Project: SRD Revision B

Power Supply

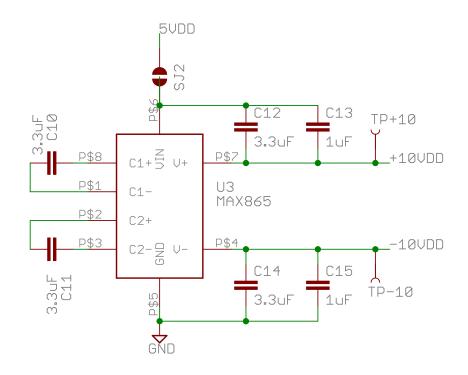
Dual LDO. TPD MIC5392/3 DVDD VOUT1 VIN⁻ VOUT2 P\$6 EN1 EN2 P\$4 AVDD C2 С3 TPA 1uF 1uF _ 1uF P\$7 P\$3 Need to edit the footprint of this 8pin part.
